Safety Recall

N232426400 Tailgate May Open Unexpectedly

Release Date: February 2024

Revision: 01

6554952

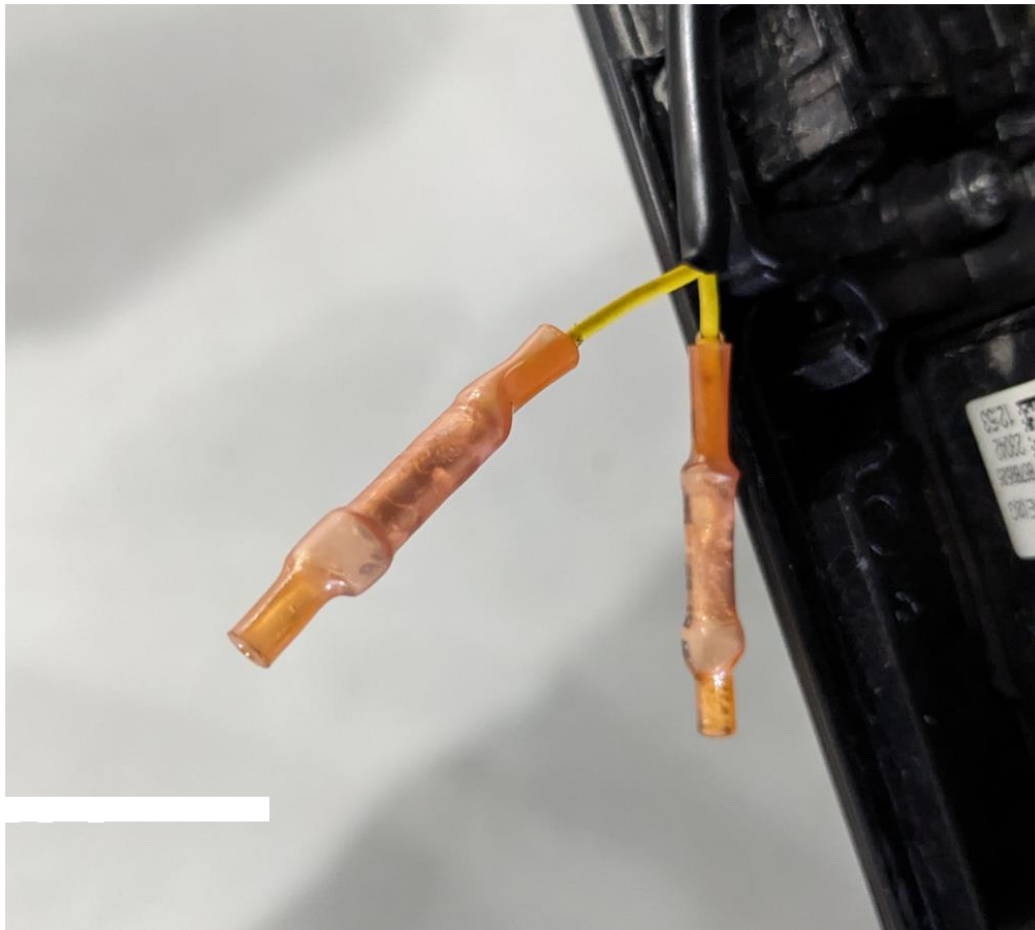
2. Cut the yellow wires close to the switch as shown, being sure to stagger the cuts by at least one inch.
3. Using red duraseal splice sleeves, cover the exposed harness end of both yellow wires.

4. Heat the sleeves until they have shrunk and sealed the wires completely.

6554953

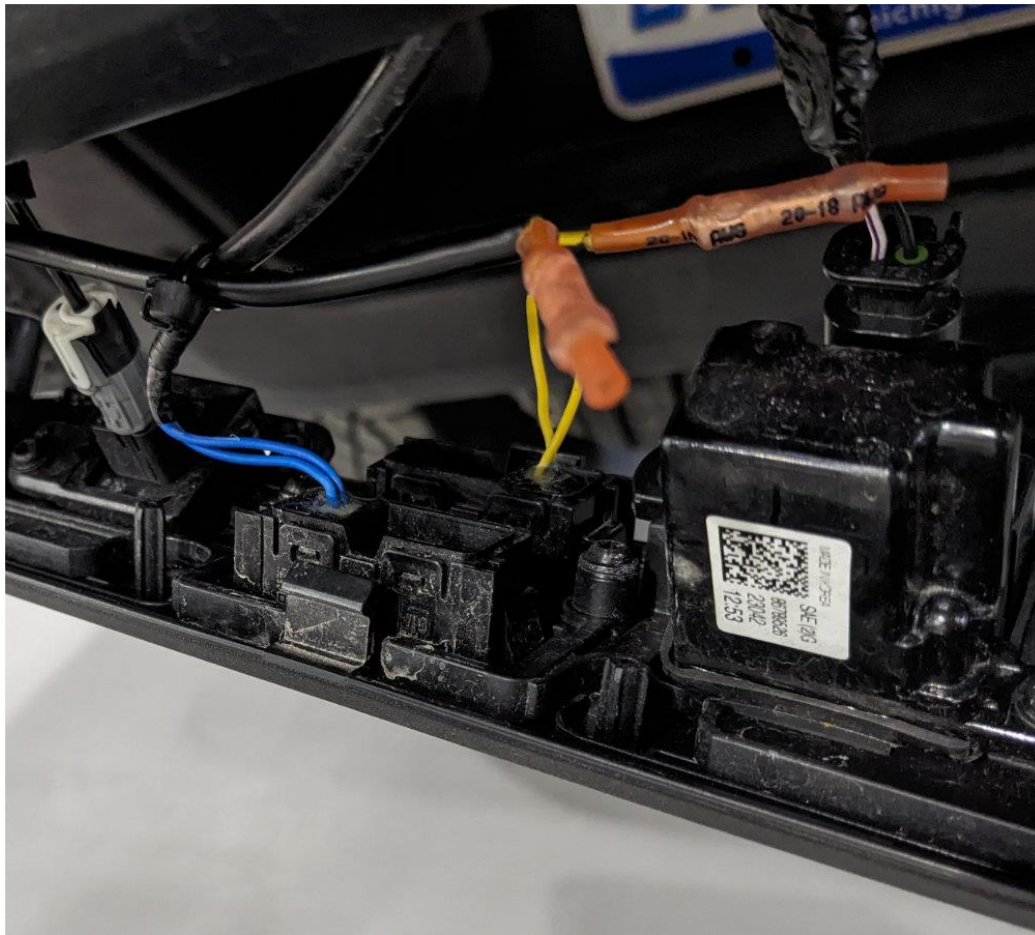
5. (Multi-pro Tailgates Only) Zip tie the yellow harness to the blue harness as shown.
6. Reinstall the Liftgate Exterior Release Switch. Refer to *Liftgate Exterior Release Switch Replacement* in SI.
7. **The Notice to Customer at the end of this bulletin must be provided to the customer for all inventory vehicles sold to customers, and current owner's that had the main liftgate switch disable repair completed. Note: Dealers should also retain a copy for their files.**
